A COMPANY OF THE SWATCH GROUP	Product Change Notification PCN	Nr. 180312-06 Publishing Date: March 21 st , 2018
---	--	--

Product information			
Item affected / Type	Tray for Holder SMTU1632-LF		
Part - Nr. (SAP)	701130	Drawing-Nr.	n/a

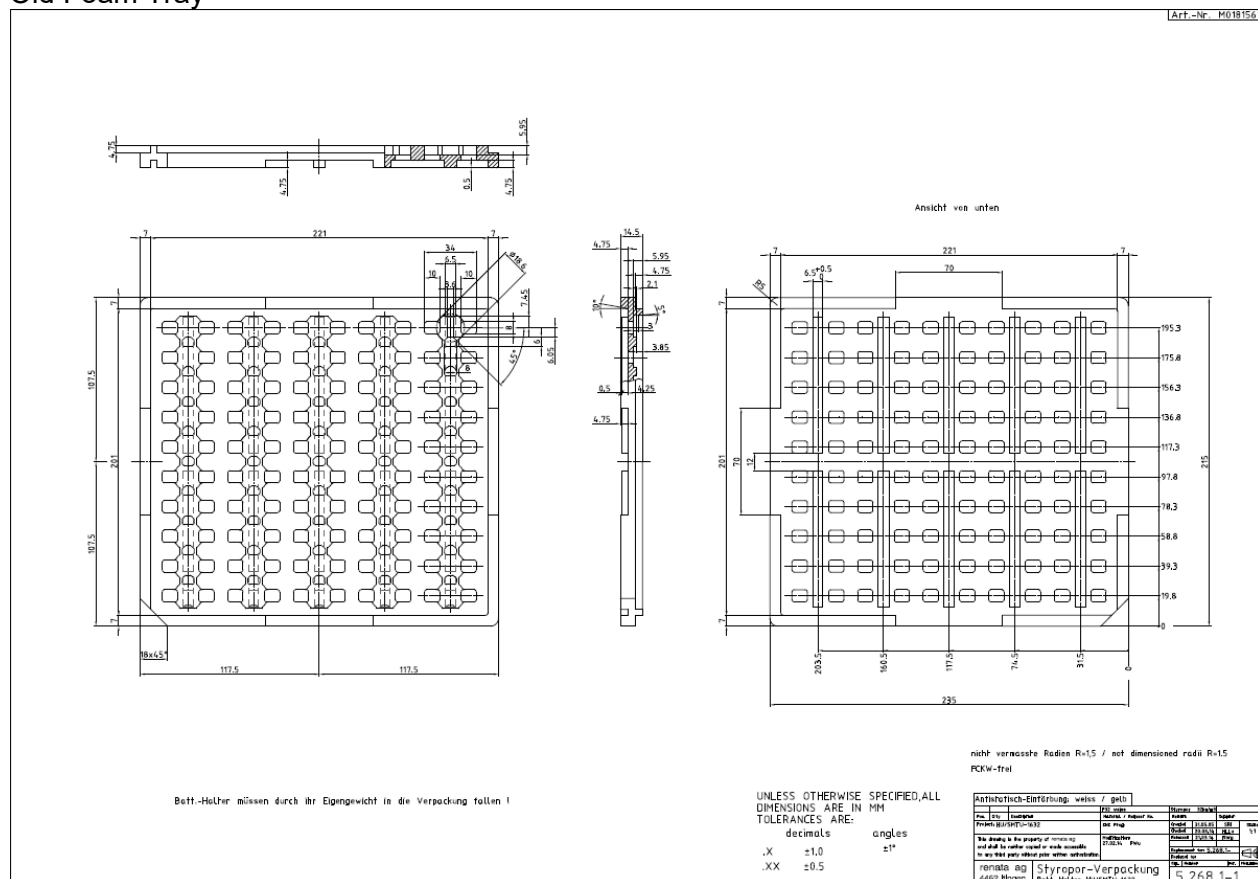
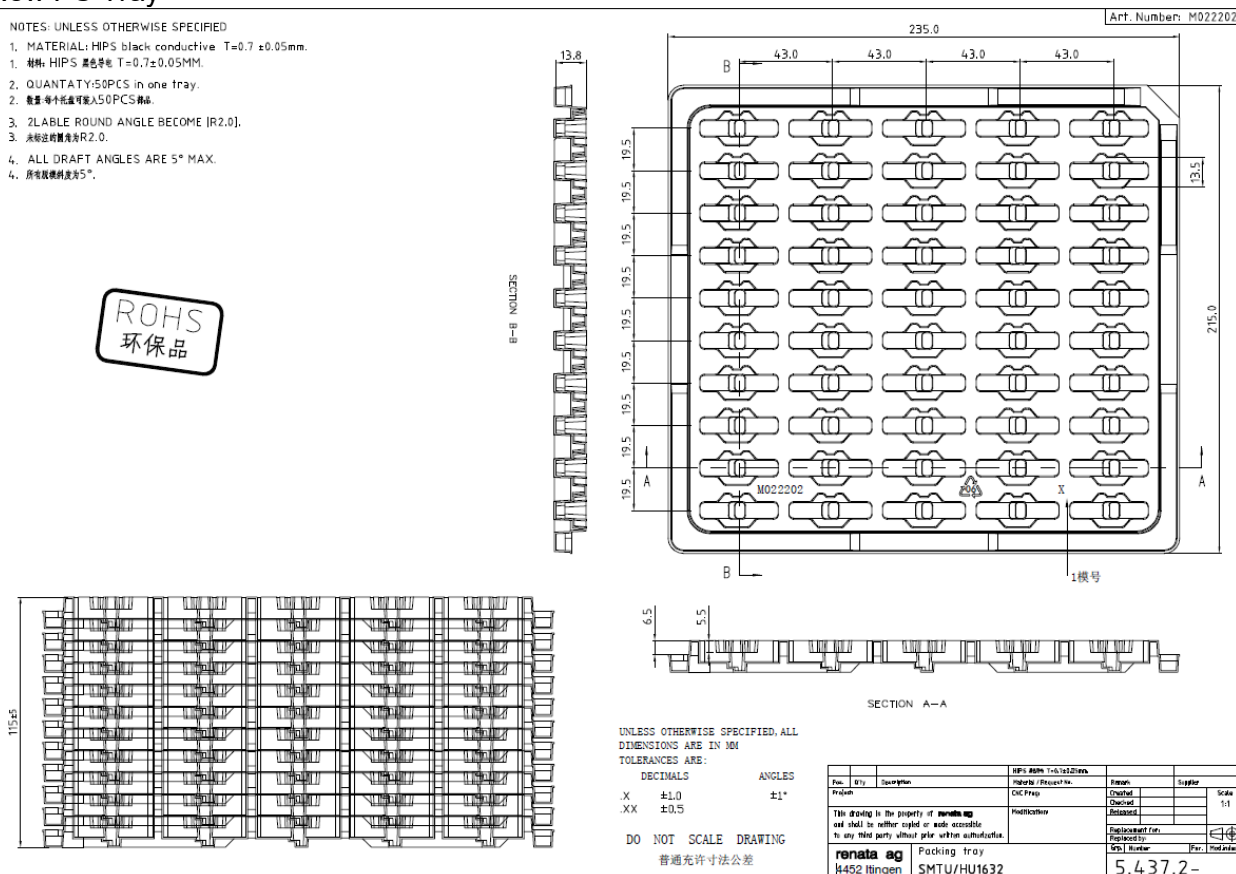
Product Change Notification	Description and reason of change
	Replacement of existing foam trays with PS (Polystyrene) material trays Drawing no. of Foam tray 5.268.1-1 Drawing no. of PS tray 5.437.2- Both drawing in attachment to compare. Same functions as PS tray Antistatic value: $10^3 \sim 10^6$ Quantities per Tray and also per shrinked pack will be kept unchanged. Placing of holders within in tray will remain unchanged Height of unit packing will be different. Current height for unit package foam tray: 101.3mm Estimate height for unit package PS trays 115.0mm Manufacturer part number will remain unchanged Change will be controlled by Lot number. Rolling change expected. Rollout of old tray expected to start in December 2020

1. MATERIAL: HIPS black conductive T=0.7 ±0.05mm.
1. 材料: HIPS 黑色导电 T=0.7±0.05MM.
2. QUANTITY:50PCS in one tray.
2. 数量:每个托盘中装50PCS样品.
3. 2LABLE ROUND ANGLE BECOME [R2.0].
3. 未标注的圆角为R2.0.
4. ALL DRAFT ANGLES ARE 5° MAX.
4. 所有拔模斜度为5°.
